PURCHASING SECTION
13450 – 104 Avenue, Surrey BC V3T 1V8
Tel: 604-590-7274
E-mail: purchasing@surrey.ca
ADDENDUM #3

REQUEST FOR QUOTATIONS (RFQ) NO.: 1220-040-2018-026
TITLE: CONSTRUCTION SERVICES
RENOVATIONS, SURREY RCMP DISTRICTS 2 & 3
ADDENDUM ISSUE DATE: August 3, 2018
REVISED CLOSING DATE: prefer to receive Quotations on or before:
August 10, 2018

FIBERGLASS WALL ASSEMBLY

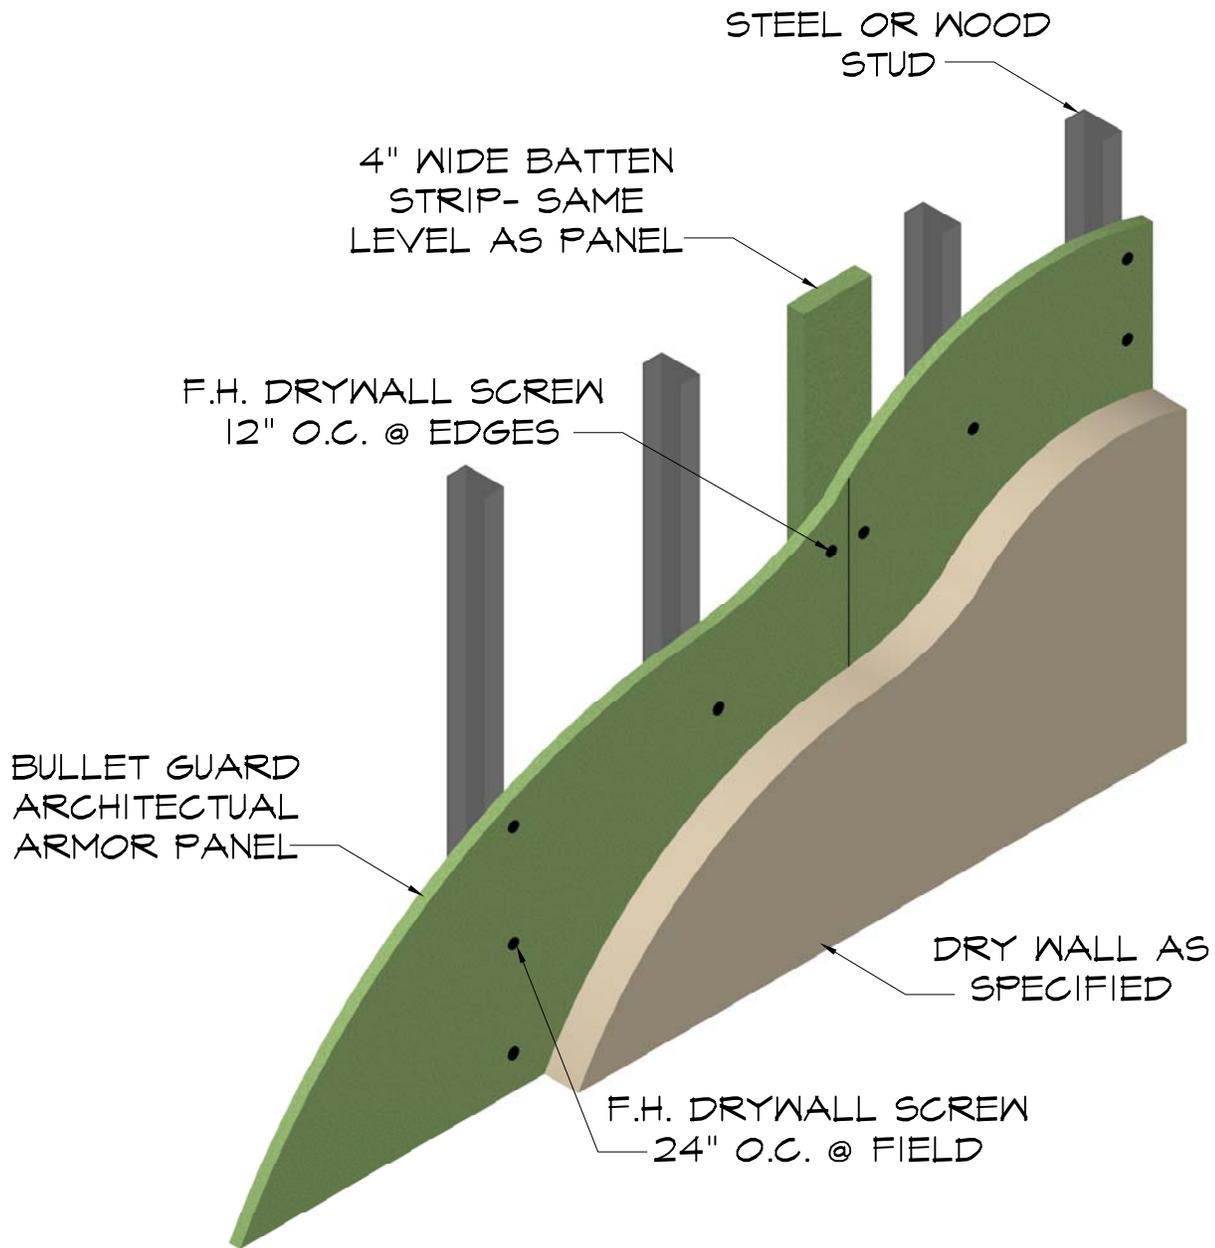
Q9: Please see attached level 1 ballistic panels for your approval.

Q14: Please see attached level 1 ballistic panels for your approval.

A9: Specifications sheets provided for ballistic panels are acceptable. Installation of the product must be done in accordance with the manufacturer specifications. Refer to attached approved level 1 ballistic panels.

A14: Specification sheets provided for ballistic panels are acceptable. Installation of the product must be done in accordance with the manufacturer specifications. Refer to attached approved level 1 ballistic panels.
